<b>Subject:</b> <b>09-016/17 - SEAT WARMER MALFUNCTION (CLOTH SEATS ONLY)</b>	<b>Bulletin No.:</b> 09-016/17
	<b>Last Issued:</b> 06/28/2017

2013-2016 CX-5 vehicles equipped with cloth seats.

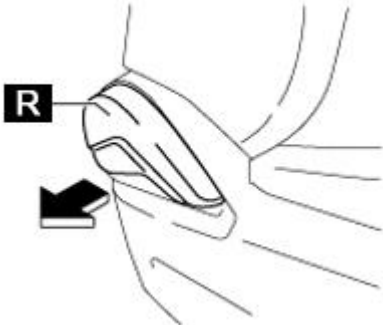
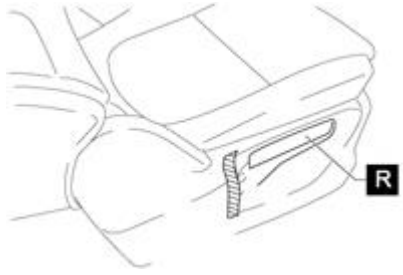
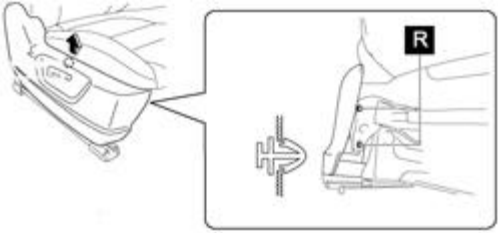
Some vehicles may exhibit the driver and/or front passenger side seat warmer(s) malfunction on any mode (High, Mid and Low). This may be caused by repeated load applied to the seat cushion (A) while the seat is occupied. A section of the heater mat (B) just above the reinforcement rod (C) in the cushion pad (A) contacts internal heater mat wire and causes damage (D).

**NOTE:** A new seat cushion pad is available with repositioned internal heater mat wire to prevent contact with reinforcement rod.
